Subject: Inspection and exchange of the exhaust damper of the power-plant. Amendment and corrections to the manuals.

Affected: ASH 26 E, Data Sheet No. 04.883, all serial numbers.

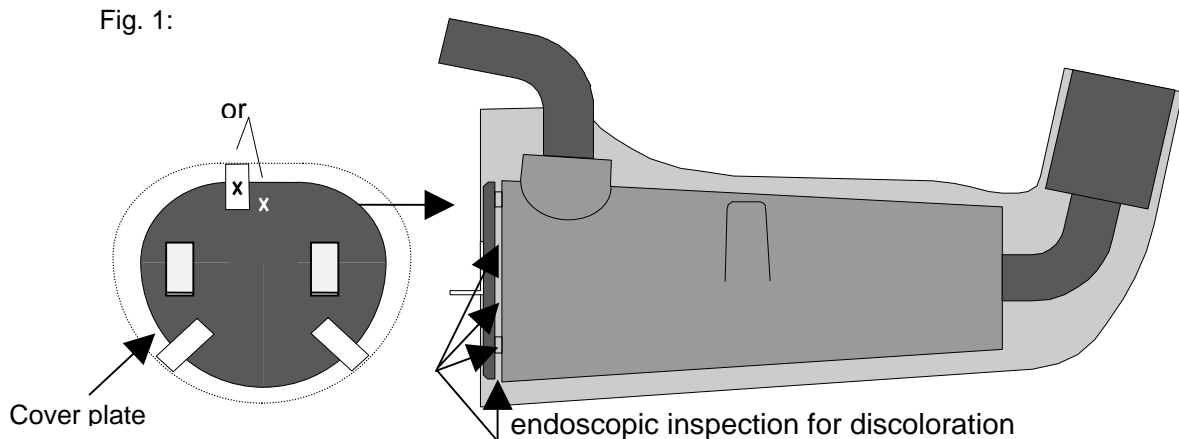
Compliance: Prior to the next engine flight all powered sailplanes must be inspected to make which version of the exhaust damper has been installed. The upgraded exhaust dampers were marked with the letter 'X'. This marking is located on the front side as shown in Fig. 1:

Where the operating time of the exhaust damper is above 40 hours, the front side of the exhaust damper behind the cover plate (see Fig.1) must be additionally inspected for tempering coloration using an endoscope. If this inspection does not reveal any discoloration from the golden-yellow basic coloring changed to a gray or bluish coloration so, a further engine operation in another two hours intervals is allowed. This inspection must be repeated in 2 hours intervals up to a maximum operating time of the exhaust damper of 60 hours.
